HERITAGE HIGH SCHOOL NEW CLASSROOM BUILDINGS, INCREMENT 2 Bid Clarification 04

June 3rd, 2021

DSA File Number: 7-H4
DSA Application Number: 01-119268
PTN: 61721-77

Owner:
Liberty Union High School District
20 Oak Street
Brentwood, CA 94513

A-8.1

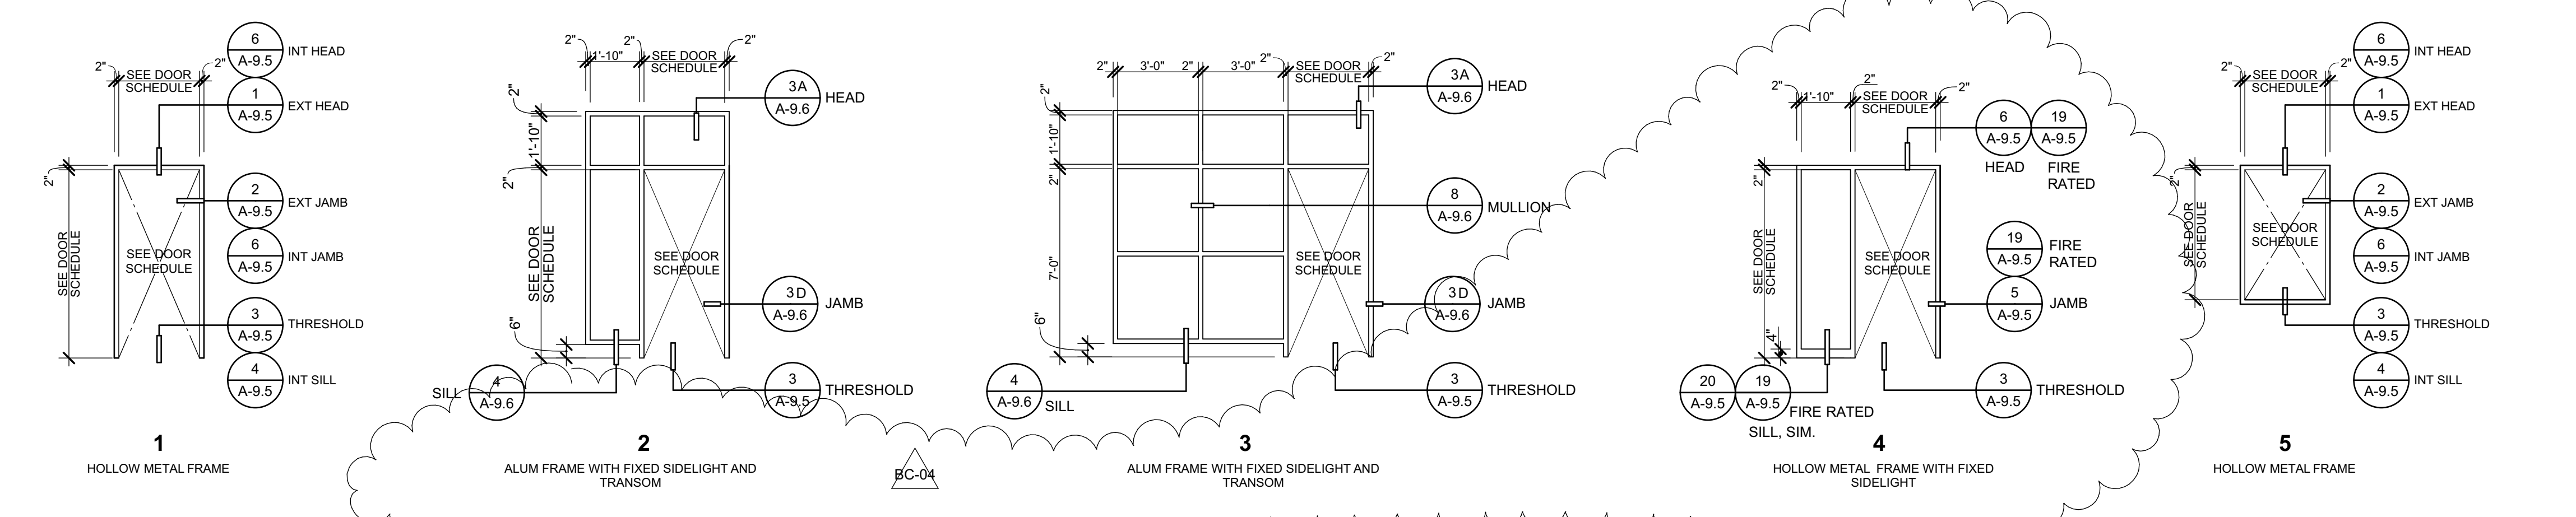
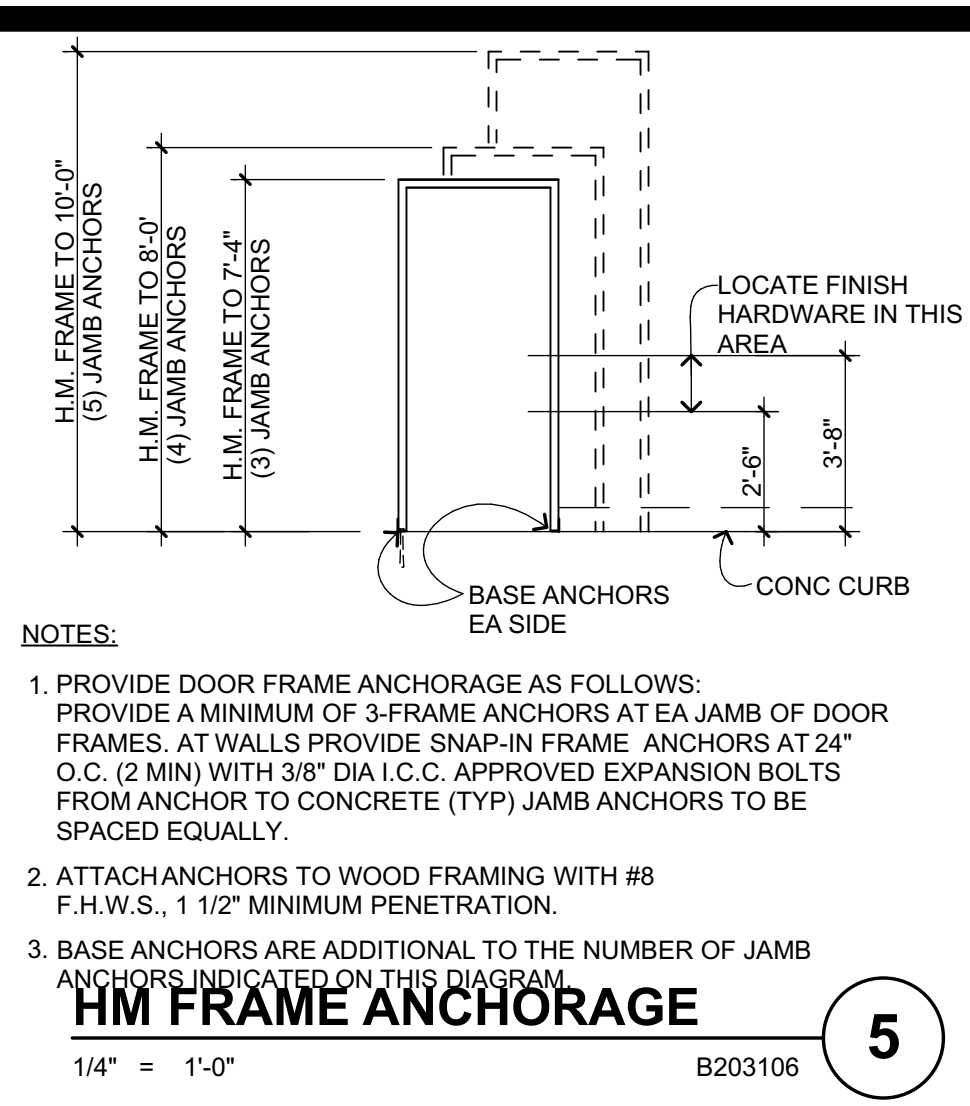
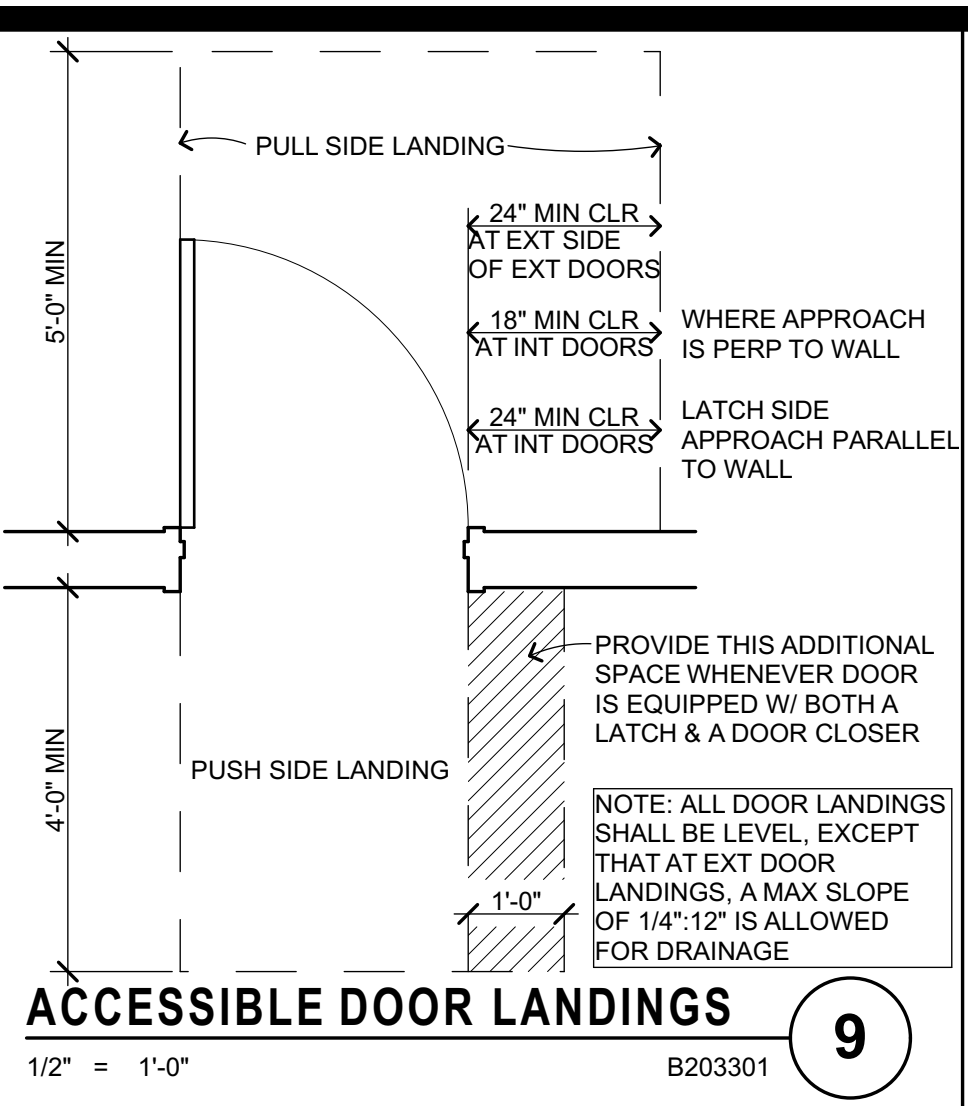
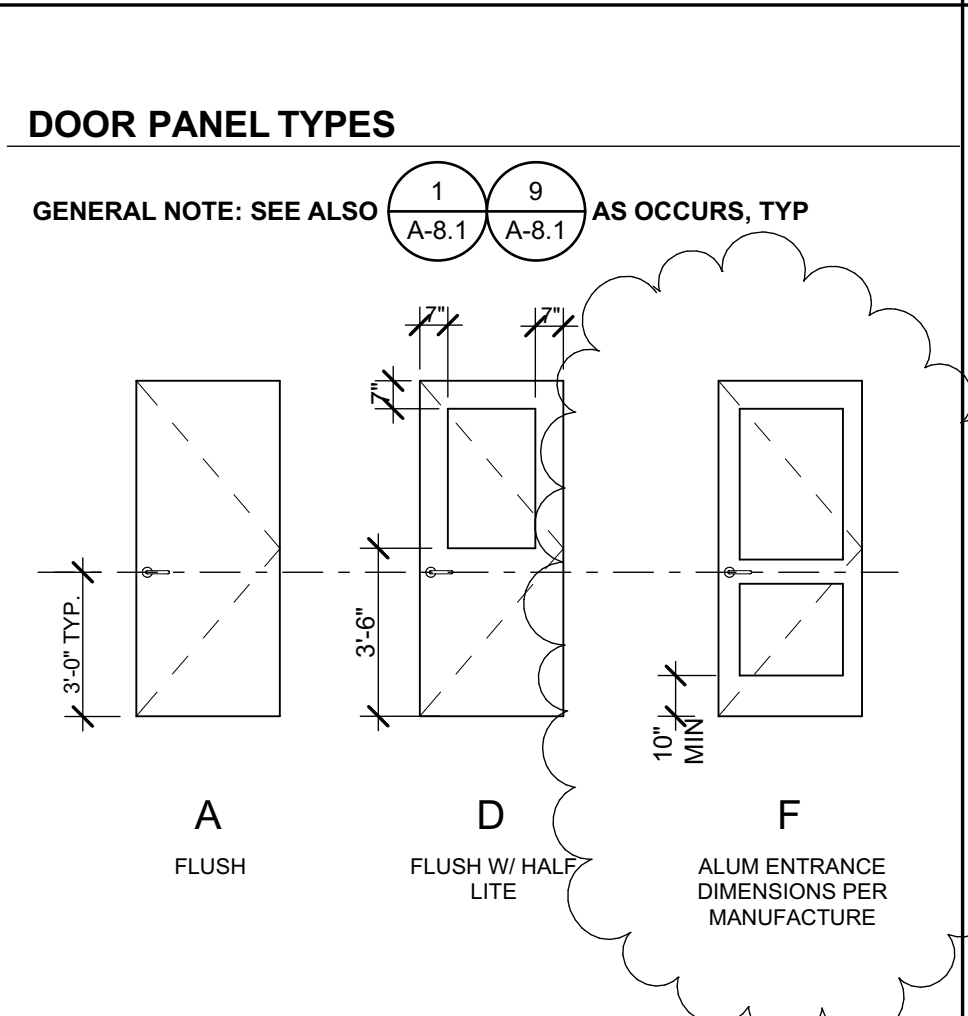
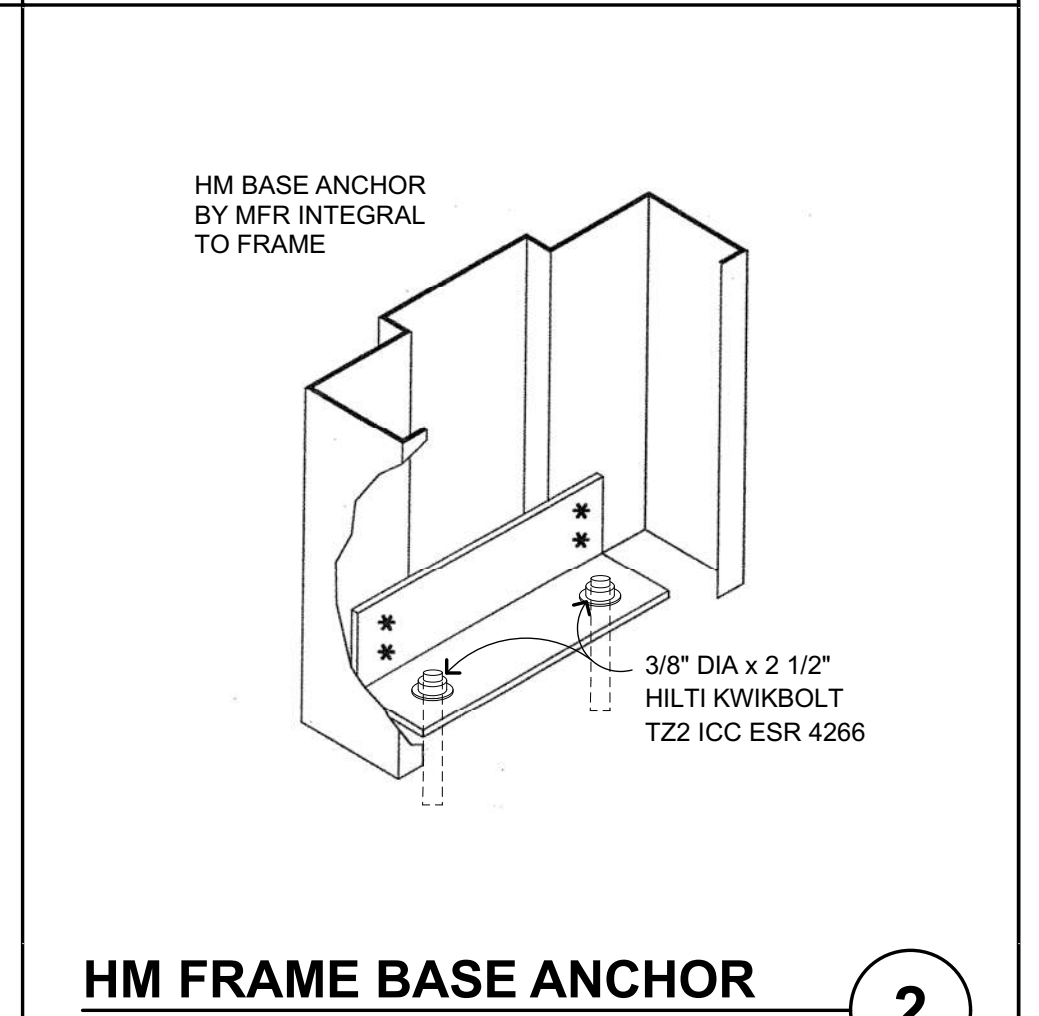
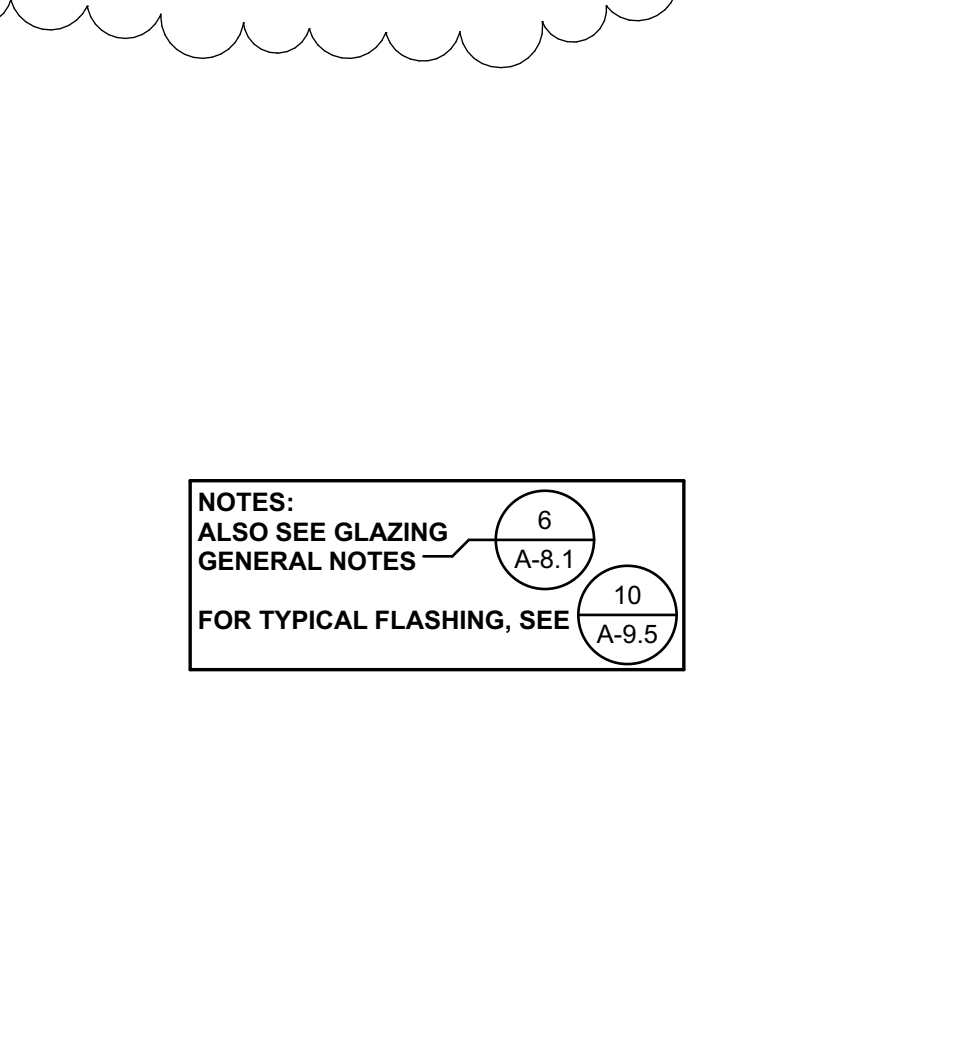
Q: (RFI #12): Frames 1, 2, 3 & 4 are listed as HM frames in elevation but called as aluminum in several locations on door schedule. Please clarify.

Q: (RFI#13): Doors B108A, B109A, B110A, B201A, B202A & B203A are listed as aluminum doors in HM frames. This is not typical, please clarify if this is true.

Q: (RFI #14): Door type D are shown as a half-lite door, that is not typically available in aluminum storefront door. Please clarify.

Q: (RFI#15): Door type A is shown as flush, while available in an aluminum it is not common. Please clarify.

Q: (RFI#18): Windows W01, W02, W03 listed as storefronts with single glass. Doors type A & D, Windows 2, 3, 4 listed as Hollow Metal (Details on page A-9.6 are aluminum with insulated glass). Please clarify.

A: Refer to attached drawing, A-8.1.

A: Refer to attached drawing, A-8.1.

A: Refer to attached drawing, A-8.1.

A: Refer to attached drawing, A-8.1.

A: Refer to attached drawing A-8.1.

P-A2.3

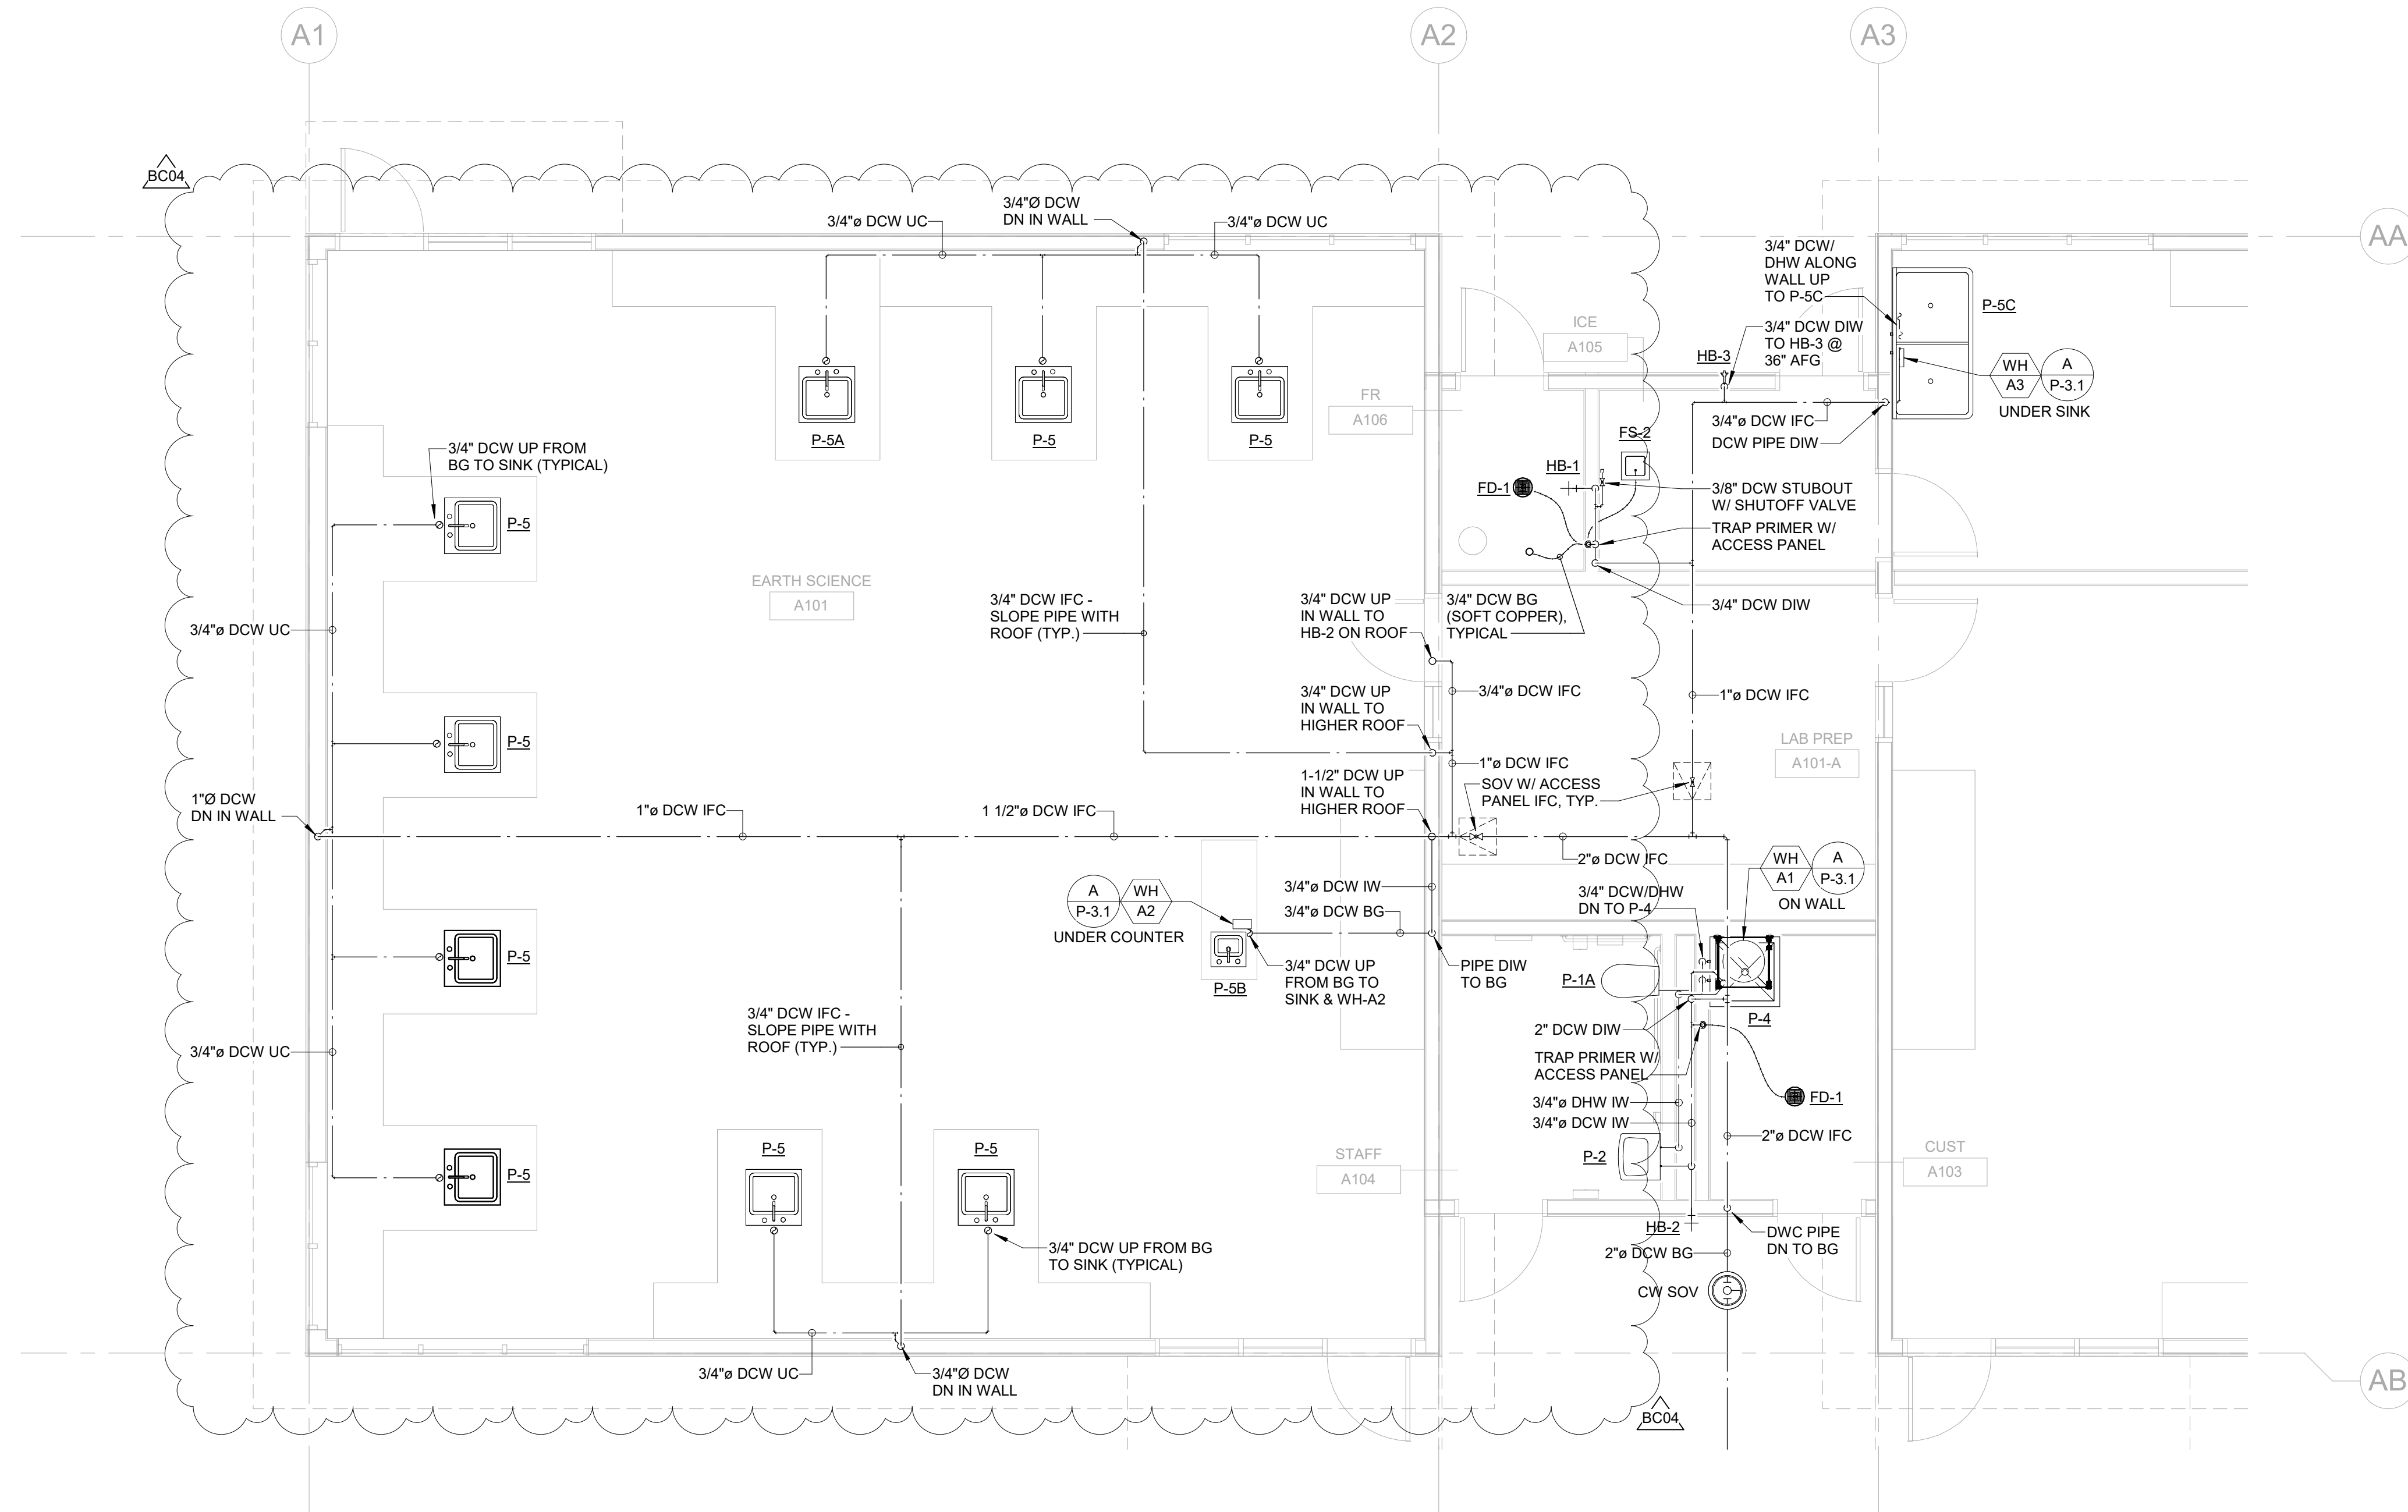
Q: (RFI#16): Plumbing plan sheet P-A2.3 clearly shows DCW piping and fittings of varying sizes serving the island sink faucets. Specifications 22 00 00/2.02-D-2 describes all under slab DCW piping to be type K soft annealed copper tubing with no fittings. Please clarify this contradiction.

A: . See changes to mechanical and plumbing drawings attached. The teachers island sink will be the only DCW BG piping without fittings.

BC 04.1

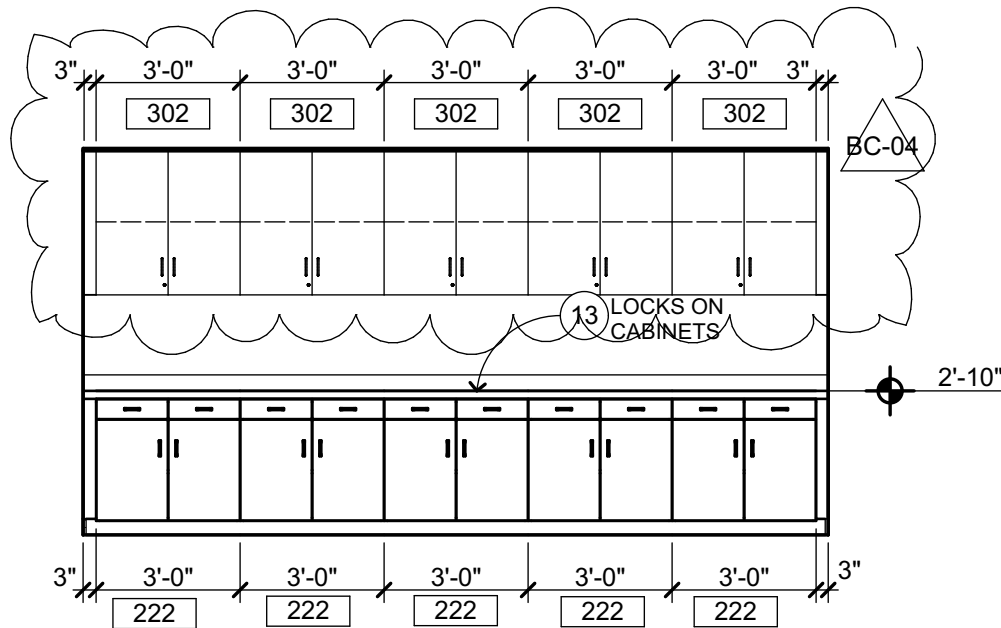
Sheet A-A7.3 BLDG-A INTERIOR ELEVATIONS

Replace SHARED OFFICE - SOUTH with the attached BC 04.1 SHARED OFFICE INT ELEV. Upper cabinets were added.
